INVITATION TO BID
BID NO. 9934
TROY SCHOOL DISTRICT 2022 PAVING PROGRAM

This Addendum is issued as modifications to the RFP previously issued to provide clarifications to the scope of work. This Addendum supersedes the original RFP. This along with the RFP becomes the bid documents.

1. For questions e-mail purchasingoffice@troy.k12.mi.us or through Buildingconnected.com.
2. Addendum #1 dated January 18, 2022 as prepared by PEA Group. (Attached)
3. Revise Bid Package, Proposal Form. Revise PF-2. Add Alternate #2 for Facilities and Operations Building. (Attached)
4. Pre-Bid Meeting Sign In Sheet dated January 18, 2022. (Attached)

C-4.1

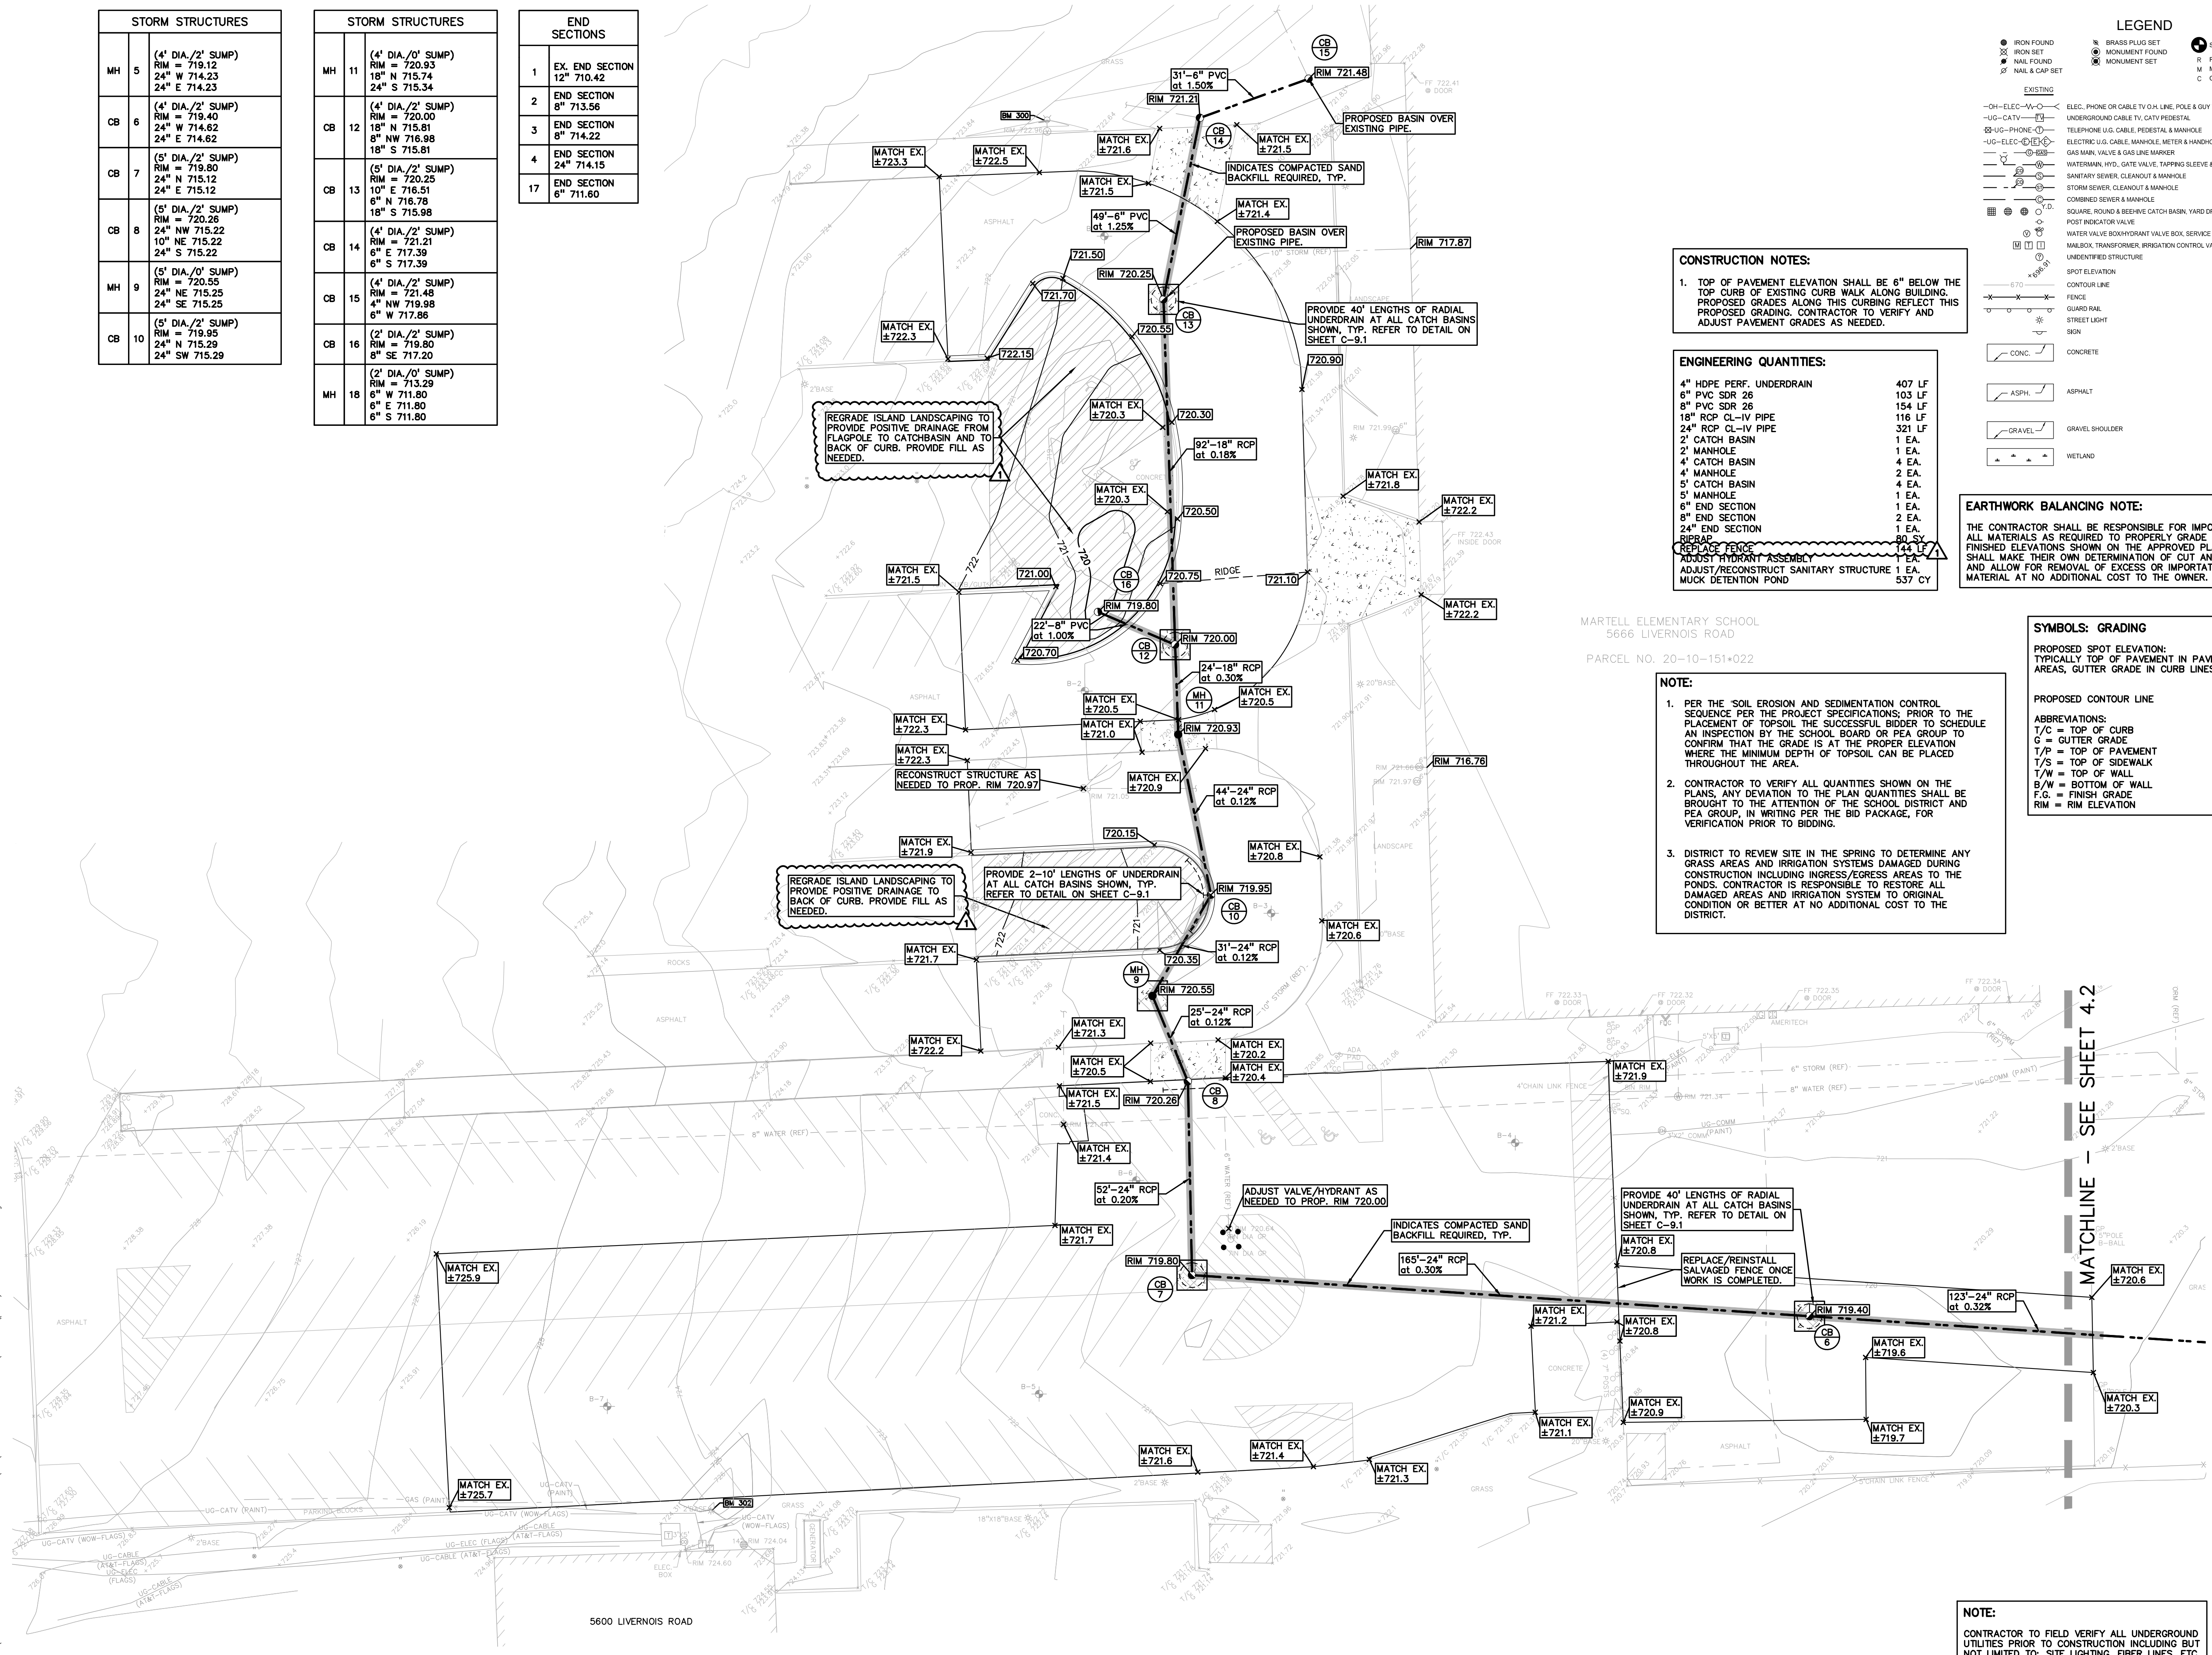
- 1. Additional call outs and grading information has been added to reflect how the island areas are to be graded and restored.
 - 2. The quantity table has been updated to reflect the revisions to the fencing.

- 4. The contractor is responsible to reinstall/replace any sections of fencing that had to be removed in order to complete the scope of work for this project in all other areas of the site, other than the west side of the pond, as shown on the plans.

PEA JOB NO. 2021-0584
P.M. RR
DN. KMM
DES. JDS
DRAWING NUMBER: C-4.2

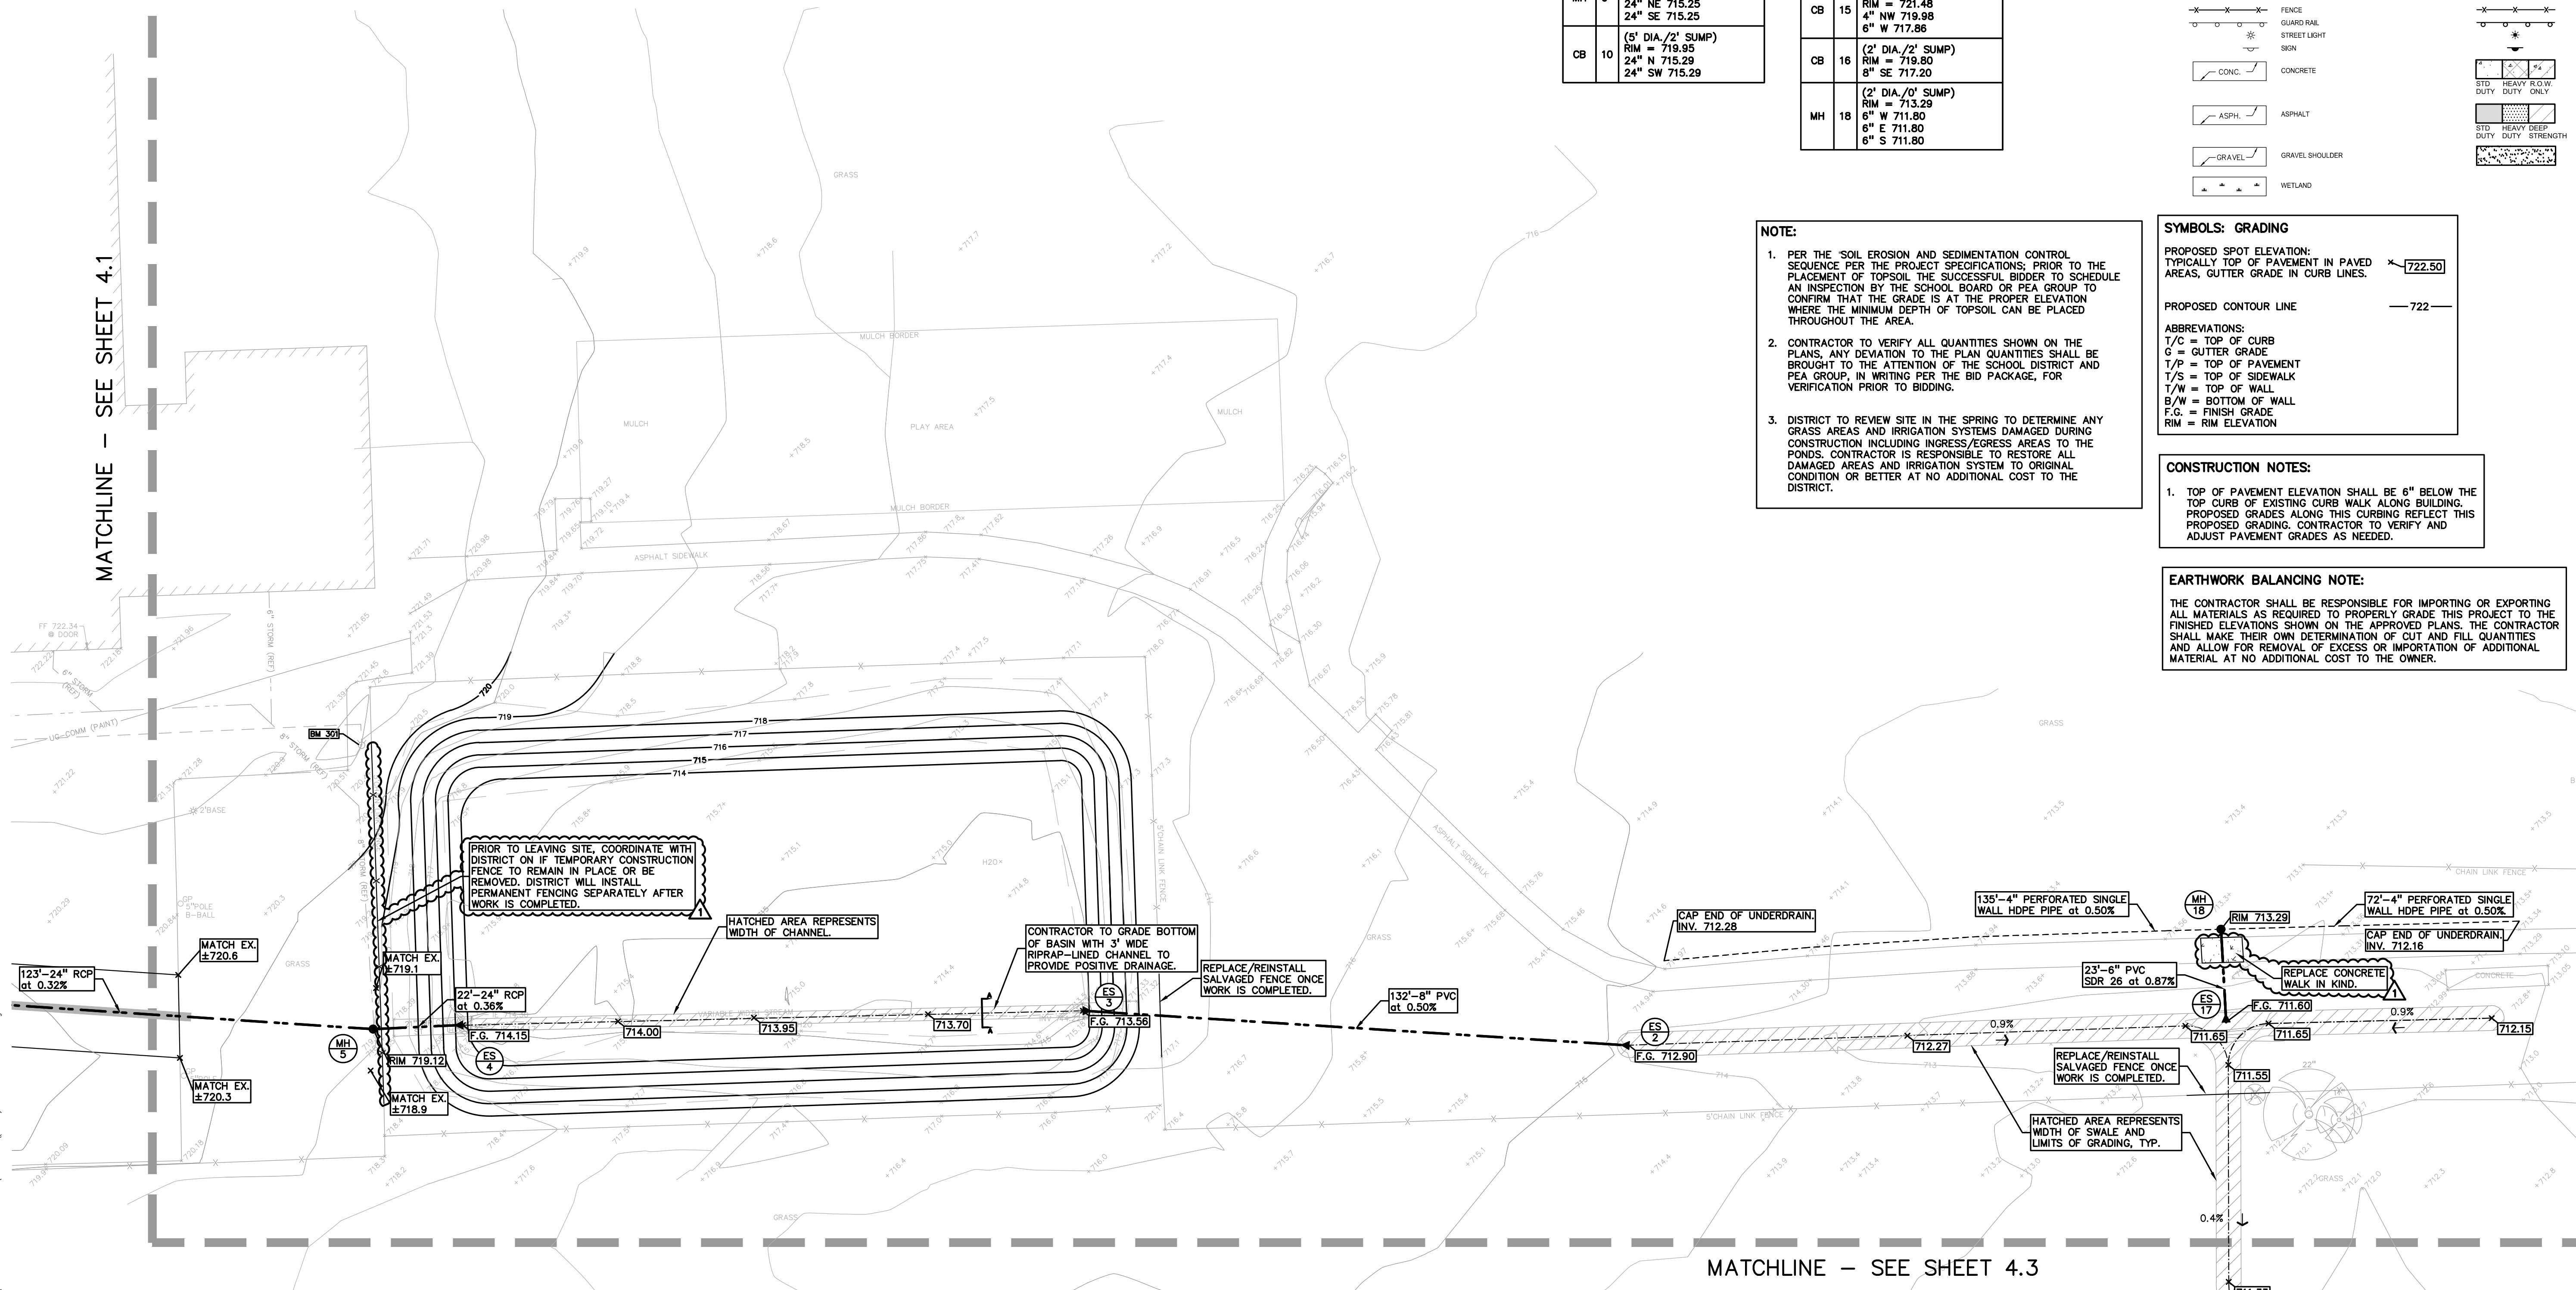
- e. Sheet C-4.2
 - 1. Section A-A for the Detention Basin Channel has been updated to reflect choking the rip rap with 21AA crushed limestone instead of grouting it in place.

DRAWING NUMBER:
C-2.0

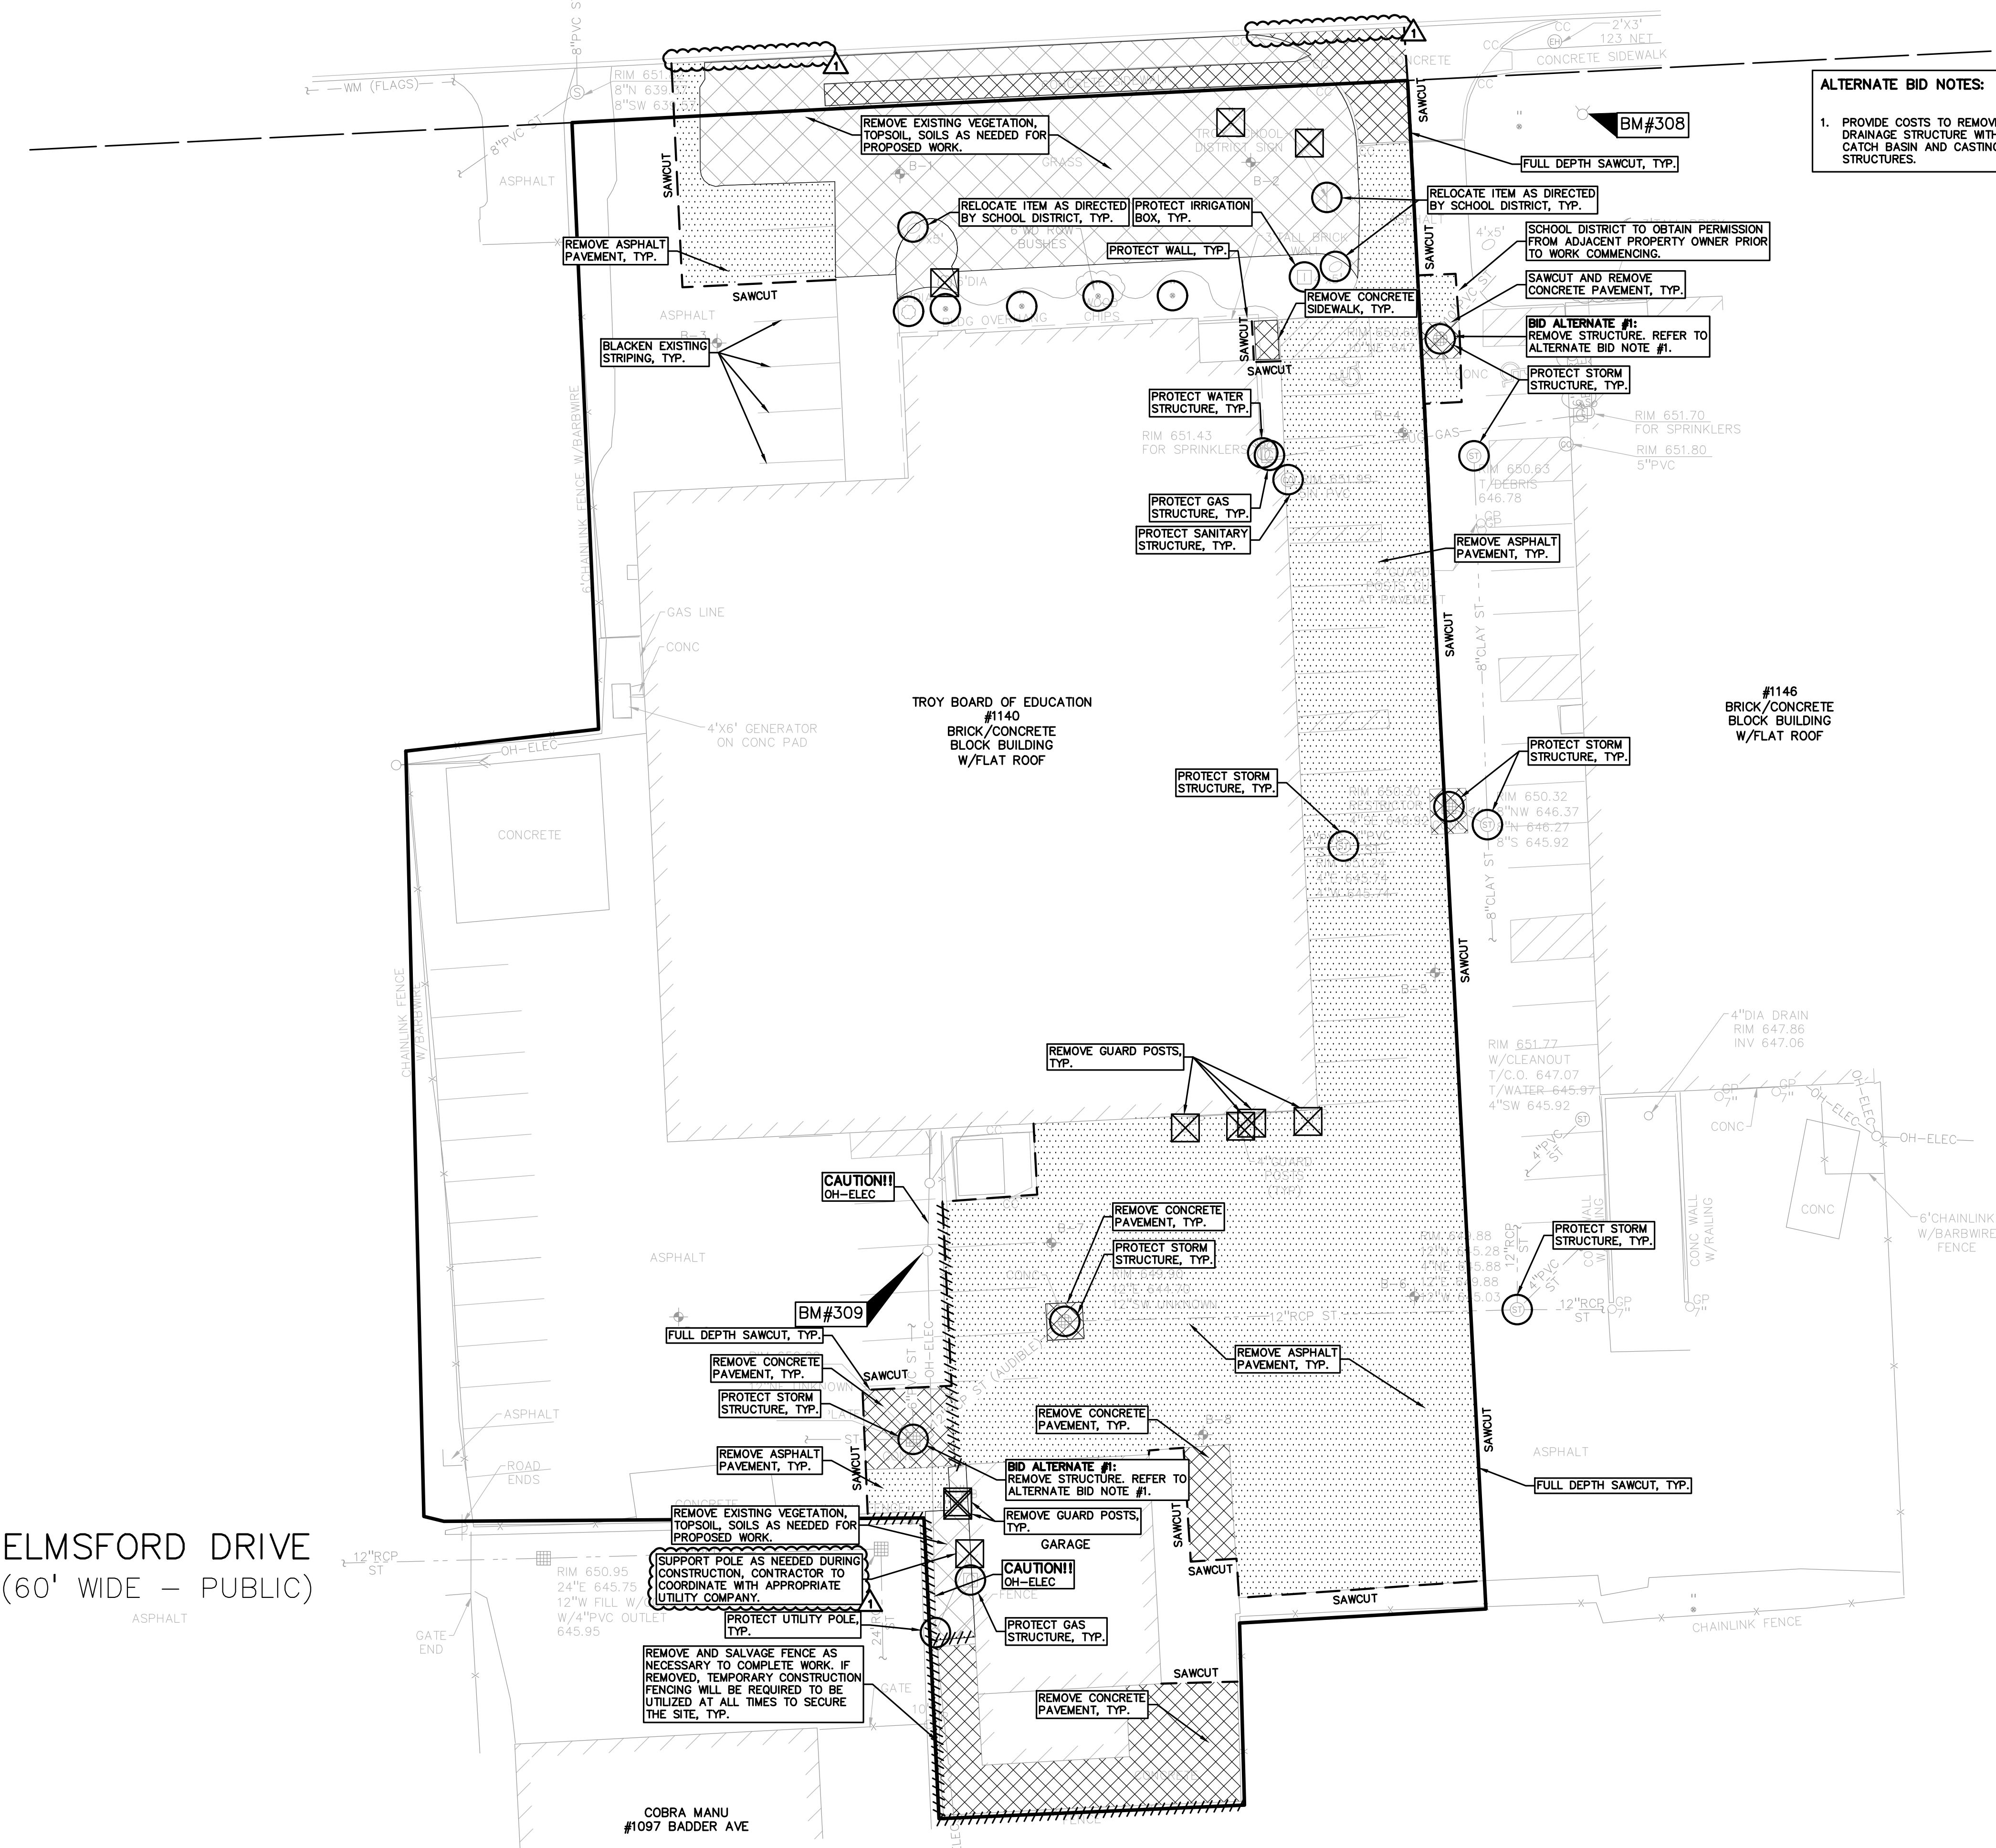
- 4. Facility and Operations Building:
 - a. Sheet C-2.0
 - 1. The call out for the curbing along Rankin Drive has been revised to reflect that the curbing will remain in place and not be removed and the curb removal quantity has been updated.

- 4. A note has been added to the plan sheet to reflect that this site will be a two phased project to allow Owner access and the actual phasing will be determined at a later time.
